Access Compliance Report Public Rights-of-Way (Curb Ramps)

Main Street: LA LIMONAR_RD		Cross Street: NEWPORT_AVE		Location:	S
ADA ID: RPRK220125135921	Ramp Type:Type 1 - Perpendicular Diagonal Initial Pass/Fail: Fail		Overall Compliance: No	Severity Score:	15
Codes/Mitigation Info/Possible Solution			Field Measurements/Component Compliance

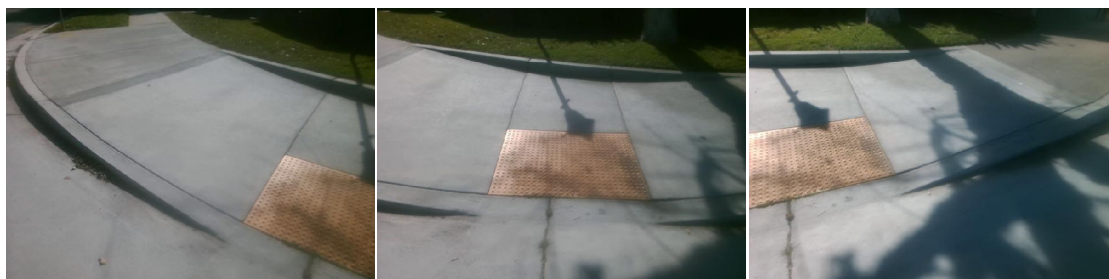
Compliance	Description	Data	Compliance	Description	Data
N/A	Ramp Length (in)	60	N/A	Flare Type LT	
Yes	Ramp Width (in)	48			N/A
Yes	Ramp Run Slope (%)	7	N/A	Flare Slope LT (%)	N/A
No	Ramp Cross Slope (%)	5.1	N/A	Flare Traversable LT	N/A
N/A	Landing Present	N/A	N/A	Flare Type RT	
N/A	Landing Length (in)	N/A			N/A
N/A	Landing Width (in)	N/A	N/A	Flare Slope RT (%)	N/A
N/A	Landing Run Slope (%)	N/A	N/A	Flare Traversable RT	N/A
N/A	Landing Cross Slope (%)	N/A	N/A	DWS Provided	N/A
N/A	Landing Movement Obstructed?	N/A	N/A	DWS Contrast	N/A
	Landing Movement Type	N/A	N/A	DWS Length (in)	N/A
N/A	Landing Shared	N/A	N/A	DWS Full Width	N/A
N/A	Clear Space	Yes	N/A	DWS Offset Left (in)	N/A
N/A	Clear Space To Crosswalk (in)	N/A	N/A	DWS Offset Right (in)	N/A
N/A	Marked Crosswalk 1	No	N/A	Marked Crosswalk 2	No
	Crossing 1 Direction	NE		Crossing 2 Direction	NW
	Marked Crosswalk 1 Width (in)	N/A		Marked Crosswalk 2 Width (in)	N/A

N/A	Ramp Inside Crosswalk 1	N/A	Yes	Ramp Inside Crosswalk 2	N/A
	Crossing 1 Slope (%)	4.4		Crossing 2 Slope (%)	7.5
	Crossing 1 Cross Slope (%)	2.9		Crossing 2 Cross Slope (%)	3.5
N/A	Gutter Ponding	N/A	N/A	Curb Slope	3.7
Yes	Gutter Lip Height (in)	0		Road Run Slope (%)	5.4
N/A	Gutter Run Slope (%)	N/A		Road Cross Slope (%)	1.5
N/A	Gutter Cross Slope (%)	N/A			
Yes	Overall Surface Condition: Acceptable		Yes	Perp Joint Present	Yes
	Cross Gutter Present?	Yes		Spandrel Present?	Yes
	Replace Cross Gutter?	No		Replace Spandrel?	No

Remove & Replace Curb Ramp With Two New Directional Ramps or Equivalent.

R304.5.3, STD 1115
